Historic Landmarks and Preservation Districts Commission

Report to the Committee

Case No: 25-COA-0181
Classification: Committee Review

Property Address: 804 E Washington St.

Figure 1: Proposed new masonry base.

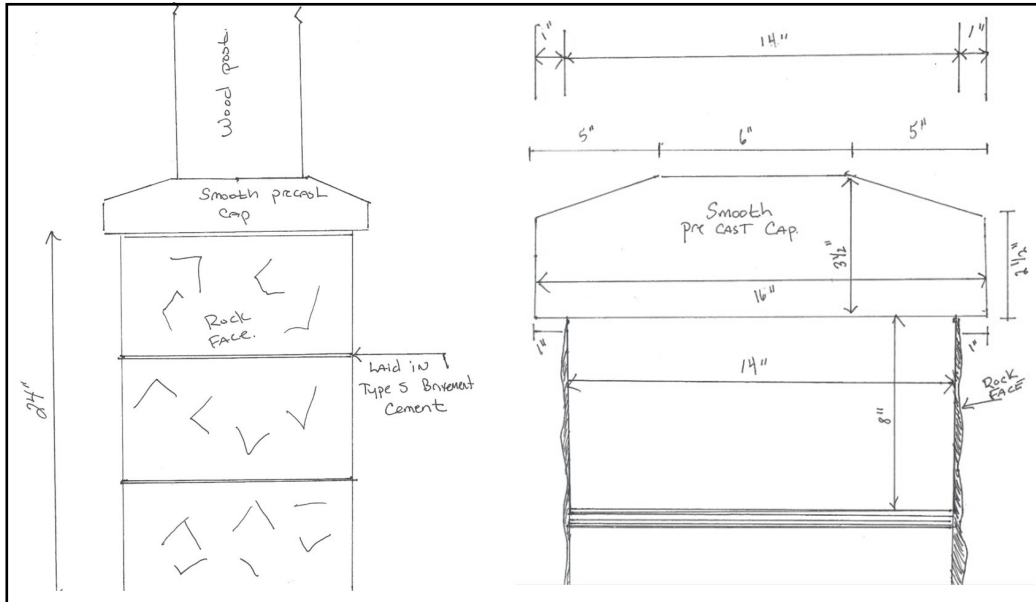
The proposal to replace the base of the wood turned porch posts with masonry and extend the porch floor generally does not meet the standard design guidelines for **Porches and Decks**, specifically **PO.1**, **PO.2**, and **PO.3**. The addition of the masonry bases does not meet **PO.1** because it is ornament that did not exist historically. **PO.2** calls for porch repair using a material that is similar to the historic structure material in style, texture, finish, composition, and proportion. While the wood post bases are deteriorated and have been poorly repaired over time, the proposed masonry bases use a material that does not mimic wood, and is a design that is not similar in style, scale, proportion, and texture to the existing. Guideline **PO.3** requires that porch element reconstruction reflect the time period of the historic structure, use in-kind materials, and match the original dimensions. The proposed masonry base will use a different material, is out of proportion and scale with the original posts and proposes a design that is much wider and heavier than the original. Furthermore, this will lead to the need to extend the porch concrete floor under the east side masonry, altering the original dimensions.

Guideline	Finding	Comment
PO.1	<p>Preserve a historic porch in its original location.</p> <ul style="list-style-type: none"> Do not move, screen, enclose, or demolish a historic porch. Do not add new ornament to a historic porch that did not exist historically or cover architectural details. Do not add a front porch to the primary facade of a historic structure that never had a porch. Screen panels may be permitted if they can be removed seasonally, are set behind porch elements, and do not damage historic fabric. 	-	<p>Although the location of the porch will not change, the proposed wood post base replacement with masonry is adding ornament that did not exist historically.</p> <p>The turned wood posts are important elements to the Victorian-era porch. Adding the masonry base would change the lightness of the design.</p>
PO.2	<p>Repair a porch in a way that maintains the historic character.</p> <ul style="list-style-type: none"> Use a material that is similar to the historic structure material in style, texture, finish, composition, and proportion. Do not cover porch or cornice elements with vinyl or aluminum siding unless historic documentation shows this material was original. Do not install porch ceilings or close in exposed eaves where none existed previously. Exposed rafters and roof decks are character-defining features for certain architectural styles. An alternative material may be considered for a porch when the appearance is similar to that of the original. Consult the Alternative Materials guidelines for more information. 	-	<p>The wood posts bases need repair. However, the proposed masonry base is a different material, style, texture, scale, and proportion than the historic wood posts.</p> <p>The design of the porch will be changed with the masonry base addition. Furthermore, the porch concrete floor will need to be extended under the masonry base to accommodate the additional width the masonry detail would create, further altering the historic fabric of the porch.</p>

As the application does not meet the applicable guidelines, Staff must recommend denial. However, Staff recommends that the applicant consider an alternative material that mimics wood and can keep the proportion of both the original porch posts and porch floor. The applicant can submit a new COA application to continue working on the repair.

Figure 2: Proposed extension of the porch floor under the new masonry base, shown in yellow.

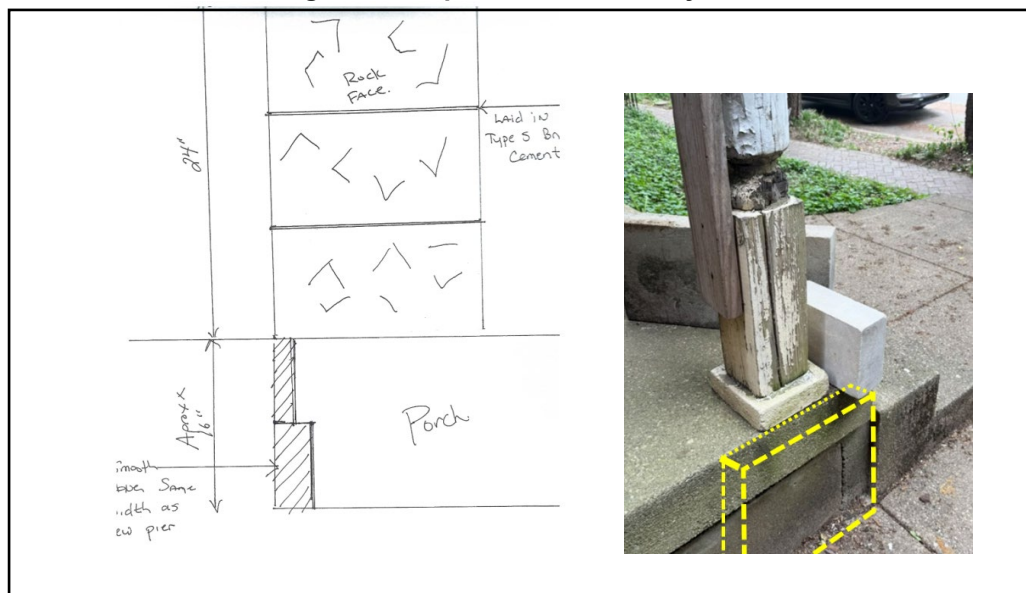
PO.3	<p>If reconstruction is required, design porch elements in a way that reflects the time period of the historic structure and use in-kind materials. Consult the Alternative Materials guidelines for more information.</p> <ul style="list-style-type: none"> Install replacement flooring that closely matches the original tongue and groove flooring dimensions. Match the dimensions of the original material. Do not use over-sized boards for a porch floor. Do not replace historic stone steps unless the stone is no longer usable. Replace deteriorated porch steps with in-kind materials. Replacement steps should be of the same scale and dimensions as the original. 	-	<p>The proposed masonry base for the historic wood post bases are much larger than the original. The proportion and lightness of the porch design will be lost.</p> <p>Concrete will be used to extend the porch floor under the proposed masonry base. This will alter the original dimensions of the floor.</p>
